## Report to the Future Melbourne Committee

### Ministerial Planning Referral: TPMR-2021-10 100-106 Franklin Street, Melbourne

19 October 2021

1. The purpose of this report is to advise the Future Melbourne Committee of a Ministerial Planning Application seeking approval for partial demolition and the construction of a multi-storey mixed use development, including use of the land for a minor sport and recreation facility (basketball court) at 100-106 Franklin Street, Melbourne (refer Attachment 2 – Locality Plan).

Figure 8 Level 2 floor plan showing basketball court at rear (Source: Applicant)

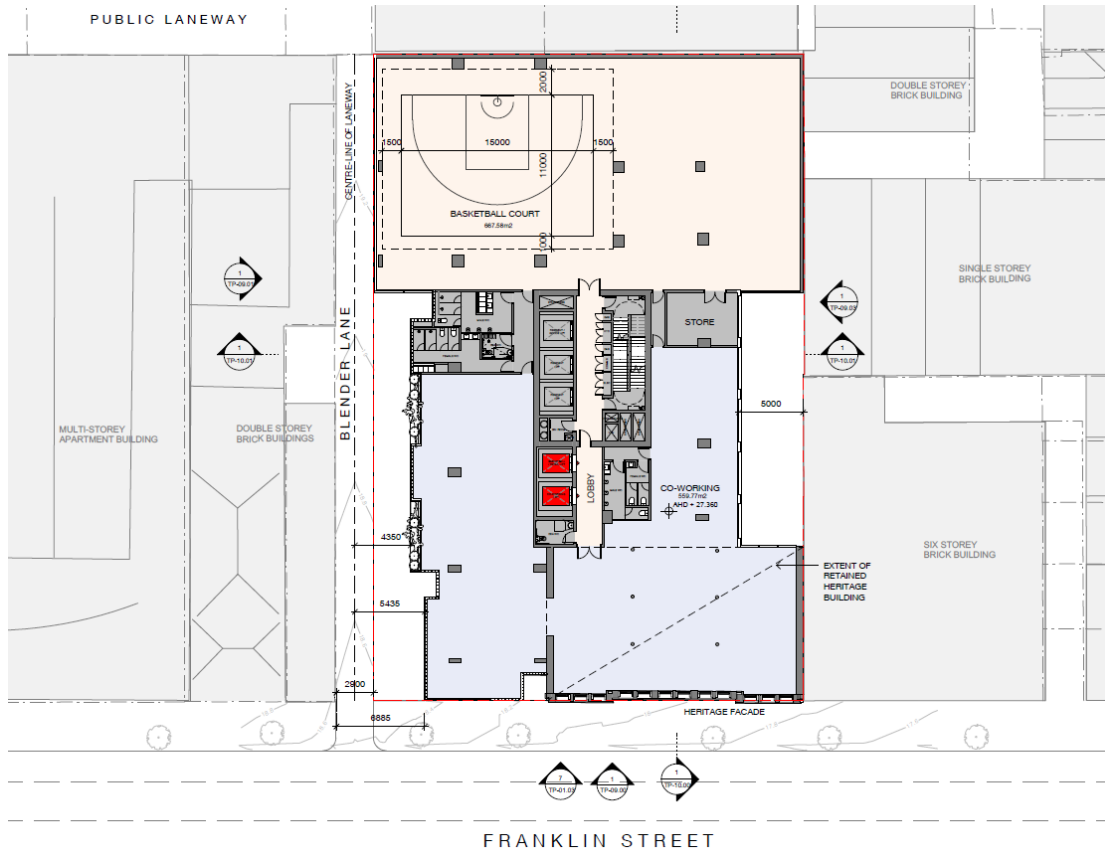
The facility is consistent with planning policy that seeks to provide conveniently located opportunities for active recreation and the creation of open space for outdoor recreation.

Figure 9 Modified tower floorplate (Source: Applicant)

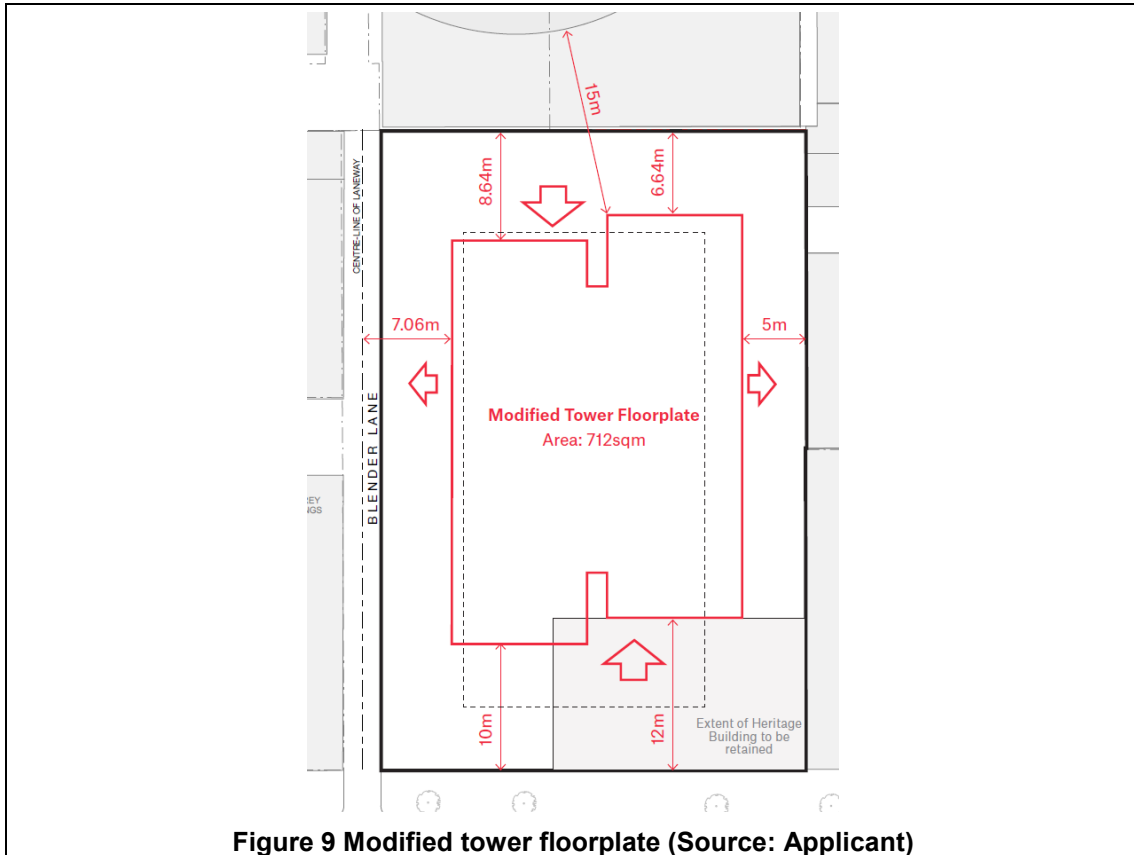
<p><b>Assessment:</b></p> <p>The application proposes to meet the modified requirement set out above.</p> <p>Setbacks are proposed in line with Figure 9 below.</p> <p>This is an appropriate response as:</p> <ul style="list-style-type: none"> <li>• Separation from the QVM Munro development to the north will ensure no unreasonable overlooking between apartments on both sites;</li> <li>• The 5 metre setback to the east will have no amenity impact as there are no habitable room windows on the adjoining site that would be impacted; and</li> <li>• The setback from the centre of Blender Lane will allow adequate separation from the existing double storey dwelling on the west side of the lane.</li> </ul> <p>The proposed setbacks will ensure acceptable levels of sunlight are achieved in the public realm and there are no detrimental wind impacts as discussed in the following sections.</p>

Table: Assessment of proposed development against DDO10 Tower floorplate requirement			
Design Element:	Preferred Requirement (Figure 3)	Modified Requirement (Figure 3)	Built Form Outcomes
<b>Tower floorplate</b>	The tower floorplate is determined by the preferred requirement for building setbacks from side and rear boundaries and tower separation within a site, and the modified requirement for building setback(s) above the street wall.	<p>The tower floorplates above the street wall for a tower above 80 metres in height may be adjusted in terms of location and/or shape but must not:</p> <ul style="list-style-type: none"> <li>▪ Result in an increase in the floorplate area;</li> <li>▪ be situated less than 5 metres from a side or rear boundary (or from the centre line of an adjoining laneway);</li> <li>▪ be less than 5 metres to a street boundary;</li> <li>▪ be less than 10 metres to an adjoining tower on the site.</li> </ul>	<p>The adjusted floorplate is designed and spaced to:</p> <ul style="list-style-type: none"> <li>▪ reduce impact on existing and potential neighbours in terms of privacy, outlook, daylight and sunlight access.</li> <li>▪ minimise visual bulk.</li> <li>▪ reduce impact on public spaces, including overshadowing and wind effects and reduced visual dominance.</li> </ul>

<ul style="list-style-type: none"> <li>▪ buildings do not visually dominate heritage places and streetscapes, nor significant view lines.</li> <li>▪ buildings do not appear as a continuous wall at street level or from nearby vantage points and maintain open sky views between them.</li> </ul>
<p><i>Assessment:</i></p> <p>The tower floorplate, as shown in Figure 9 above, does not result in an increase of the floorplate area and meets all of the setbacks for modified requirements above.</p> <p>The slipped tower form serves to break up the mass of the tower when viewed from outside the site and allows an improved level of internal amenity with the central corridor access to all apartments providing natural light and ventilation.</p>
